THE MARYLAND-NATIONAL CAPITAL PARK & PLANNING COMMISSION

**MEMORANDUM**

**REVIEW TYPE:** Site Plan Review  
**APPLYING FOR:** Approval of a total of 10,880 sf Commercial Space for Retail Use

**PROJECT NAME:** Middlebrook CVS  
**CASE #:** 8-98017A  
**REVIEW BASIS:** Site Plan required in the C-3 Zone [Article 59-D]  
Allowance of Off-Site Parking [§59-E-3.4]  
Waiver for alteration to Parking Standards [§59-E-4.5] applied to [§59-E-2.71]

The blue line shows the location of the landscape strip edge with the 5-foot wide landscape area. The red line indicates the standard area for the landscape area with a 10-foot width.

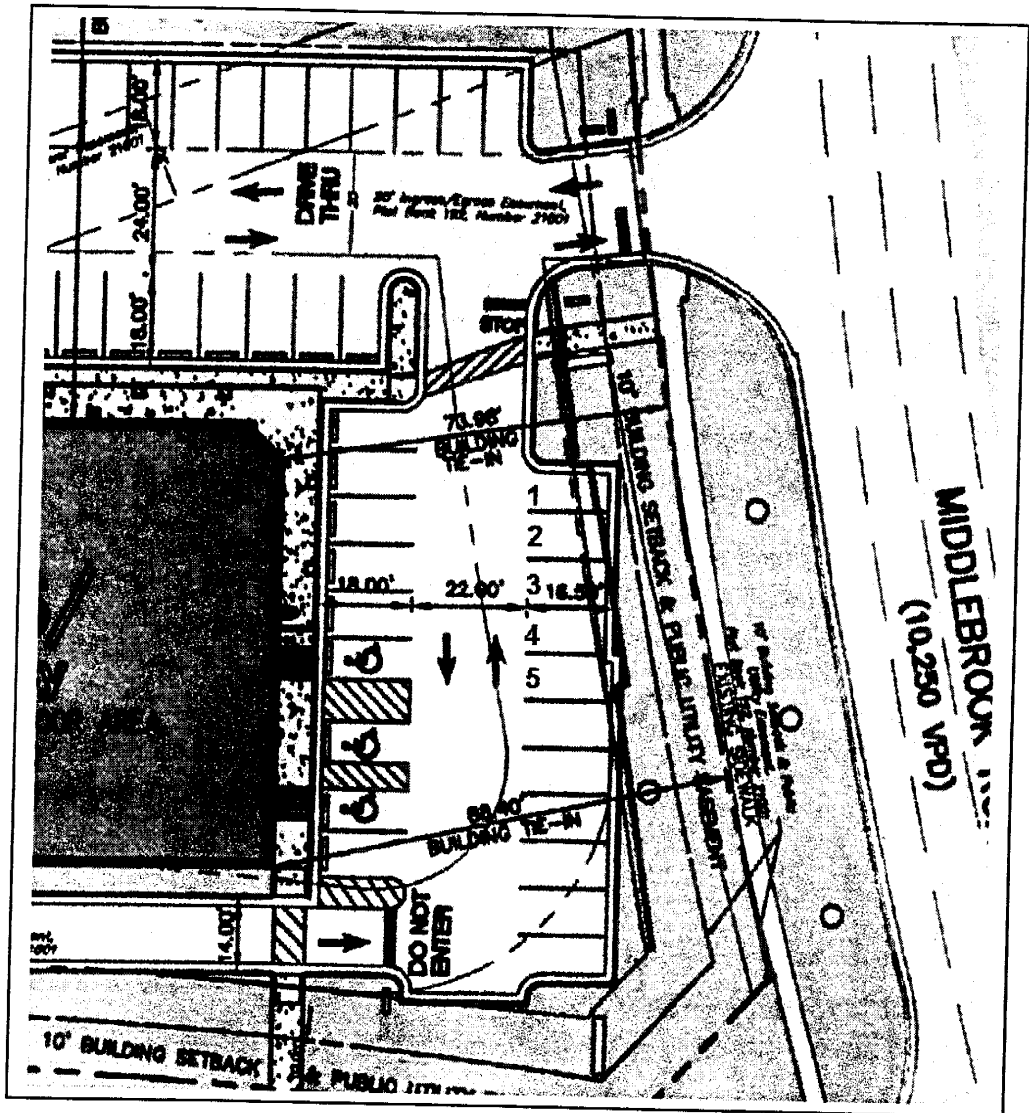
The applicant seeks a partial waiver from the requirements for landscape strip area adjacent to a street right-of-way as addressed under §59-E-2.7 of the Montgomery County Zoning Ordinance.

**Applicant Position:** The applicant requests a waiver to allow a reduction from the standard 10-foot width for a portion of the landscape strip adjacent to the Middlebrook Road ROW and public utility easement. In order to provide adequate parking supply; the proposal provides for a 5-foot landscape strip for the subject portion of frontage across 4 parking spaces.

**Staff Position:** Staff supports the applicant's request for a waiver for a portion of the landscaping area width because:

- The design with the waiver provides the same number and spacing of shade trees as would be provided without the waiver;
- The proposal with a 5-foot-wide landscape strip over a length of approximately 32 feet, will provide sufficient and attractive landscaping along the frontage (approximately 4 parking space widths);

- The majority of the parking spaces facing Middlebrook Road are adjoined by the standard 10 foot landscaping strip; in addition, the 10-foot PUE adjoins the entire frontage along the parking edge;

- Staff recommends that the applicant provide supplementary planting for the screening hedge in the form of a staggered double row of greenery along the parking lot street edge;

- The applicant proposes to enhance the street frontage with new landscaping; staff recommends that the applicant provide additional shade trees within the Middlebrook Road median, subject to review and approval by the State Highway Administration.

- a. Street Frontage
    - i. Provide three shade trees for the Middlebrook Road median, subject to review and approval by the State Highway Administration;
    - ii. Provide minimum five-foot landscape strip adjacent to the public utility easement for the five parking spaces at the north end of the parking strip facing Middlebrook Road (note: the end space to be converted to motorcycle parking);
    - iii. Replace any dead or diseased street trees within the ROW for Lots 1, 2, and 3.
  - b. Parking Areas (Lot 1, Lot 2, Lot 3)
    - i. Provide three additional shade trees pending coordination with property owners;
    - ii. Replace any dead or diseased trees pending coordination with property owners;
  - c. Conservation Easement Area
    - i. Clear trash and invasive growth;
    - ii. Replace any dead or diseased trees.
- 6. Lighting

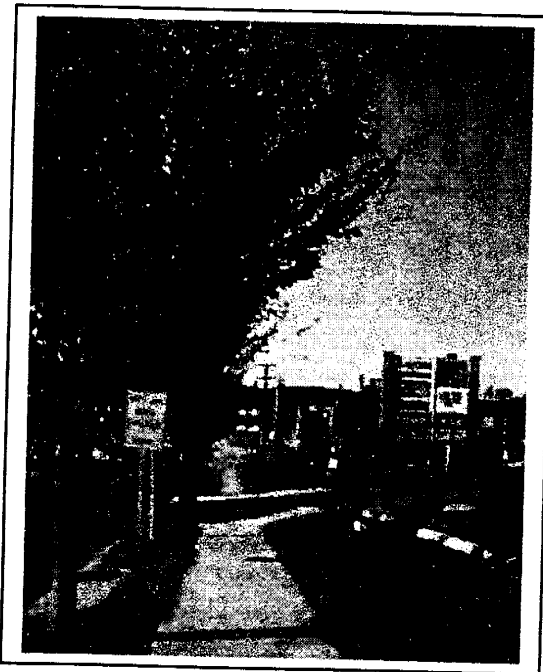
The proposal features pylon signage that is 26 feet in height.

**Applicant Position:** The signage proposed will modify existing "Friendly's" pylon signage, and comprises a standard CVS signage element.

**Staff Position:** Staff recommends that signage design conform with the *Germantown Streetscape Concept Plan, Approved March 1994* ("*Streetscape Plan*"), with signage no higher than 14 feet. Private Signage is addressed within Section 6.2 (See *Streetscape Plan, page 19*, attached). The *Streetscape Plan* recommends that "all commercial signage located . . . at Village Centers should be restricted in height, similar to [the Master Plan standards for signage at] MD 118 . . .". The *Streetscape Plan* states that signage higher than 14 feet will, among other things, contribute to visual clutter and competing roadside information.

Although the *Streetscape Plan* allows for exceptions to the above guideline, if a proposal for signage "achieves a superior design that complements architectural elements and reduces visual clutter[.]", Staff is of the opinion that the signage proposed (at 26 feet in height) does not complement the attractive elements of the proposed building design and, moreover, will increase visual clutter and detract from the compatibility among adjacent development, achieved in part through implementation of the Streetscape recommendations. Therefore, Staff concludes that the proposed signage does not meet the goals of the *Streetscape Plan* and cannot support a finding of compatibility. [See also *Discussion in Findings, page 13*, and *Memorandum from Community-Based Planning dated October 2, 2003* attached.]

- c. Provide the development program inspection schedule.
- 4. Site Design
  - a. Provide grading at 2-foot intervals to be shown on the Landscape Plan;
  - b. Remove any structures proposed within the ROW or PUE;
  - c. Provide signage design consistent with the guidelines in the *Germantown Streetscape Concept Plan* for commercial signage located at Village Centers, pursuant to Section 6.2 and Figures 2 and 14 of the *Germantown Streetscape Concept Plan*.
- 5. Landscape Design

*Detail from Germantown Streetscape Concept Plan showing extent and locations of the Village Center areas, applicable for recommended streetscape standards. The drawing shows streetscape recommendations as applied to the street frontage of MD355 and Middlebrook Road.*

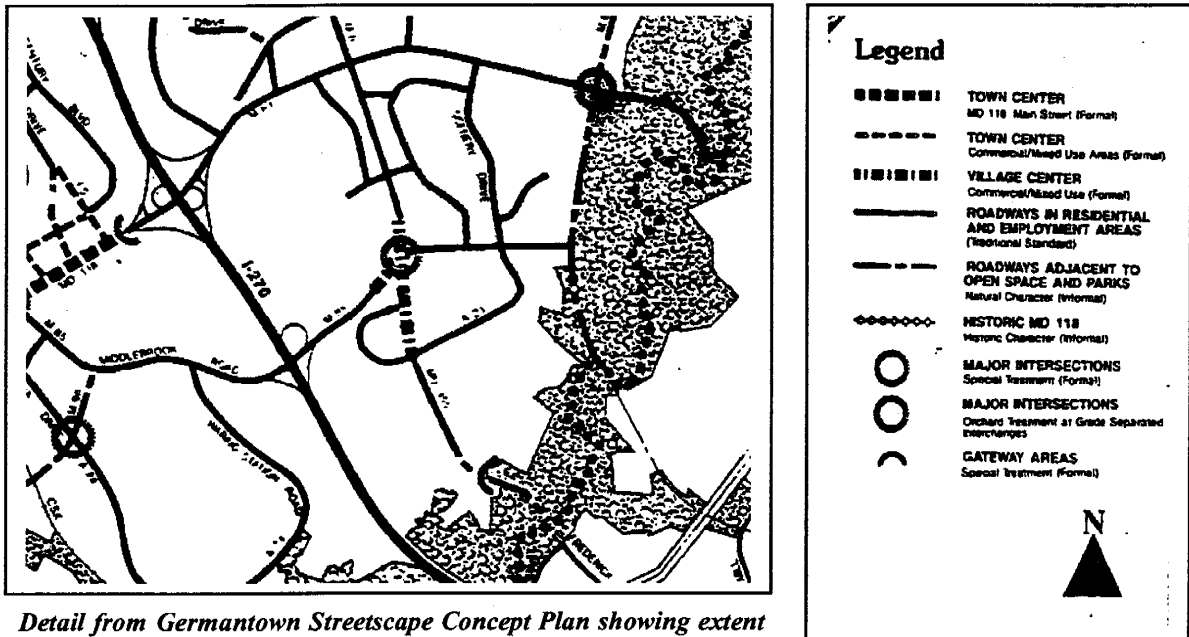
The only element of questionable compatibility concerns the pylon signage, which is proposed at a height of 26 feet (the Zoning Ordinance definition of “structure” includes signage). The proposed signage contrasts markedly with existing commercial signage along the roadways in the southeastern and southwestern quadrants of the Middlebrook Road/Rt. 355 intersection, which conform with the *Streetscape Plan* guidelines for signage. Staff is of the opinion that the signage design for this site should be consistent with signage existing in the other quadrants of the subject site’s intersection, in order to support a finding of compatibility with adjacent development. Staff recommends that signage be provided on the subject site that follows the guidelines in the *Streetscape Plan*: monument style signage that is a maximum of 14 feet in height, constructed with building materials that will achieve compatibility.

The Streetscape Concept Plan (Figure 2 on page 10 of the *Streetscape Plan*) delineates the extent of the recommended Middlebrook Village Center streetscaping along MD355 and Middlebrook Road. The latter illustration supports Staff’s recommendation that signage at the subject site should be consistent with the guidelines in the *Streetscape Plan* that restrict the height of commercial signage at Village Centers.

Staff recommends that the signage follow the *Streetscape Plan* guidelines in order to achieve a maximum of compatibility with the proposed building and with adjacent development; and furthermore, in order to achieve a maximum of attractiveness.
